**NEW PLASTIC INNER DOOR AND FLUFF FILTER IN HP TUMBLE DRYER.**

2. New inner door – 1366098026.

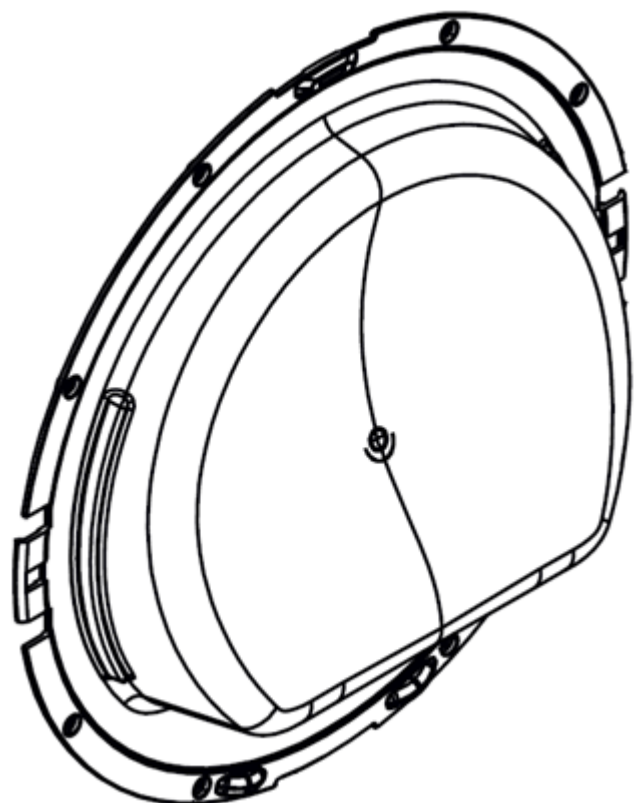
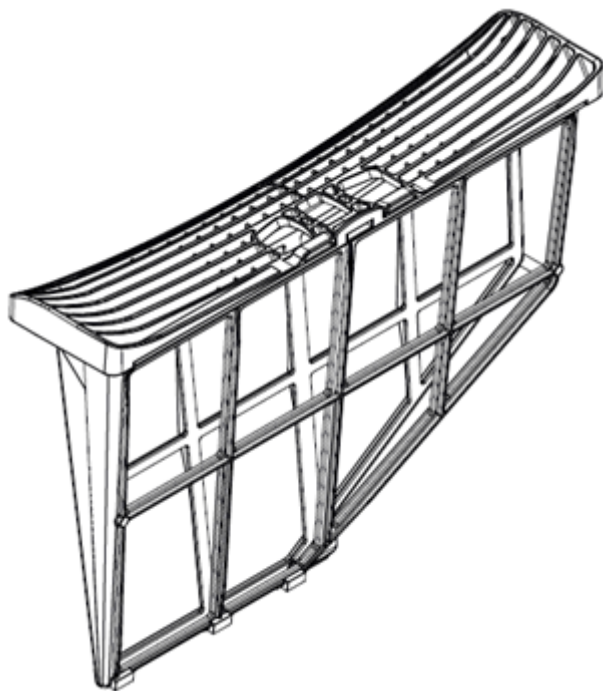
To lower risk of clothes being pinched between plastic door and fluff filter the shape of inner door has been modified to match the glass one. Fluff filter has been replaced by the one used with glass door. This change has been made in all appliances with serial number from 329xxxxx.

Both plastic inner door and fluff filter have to be replaced by new ones:
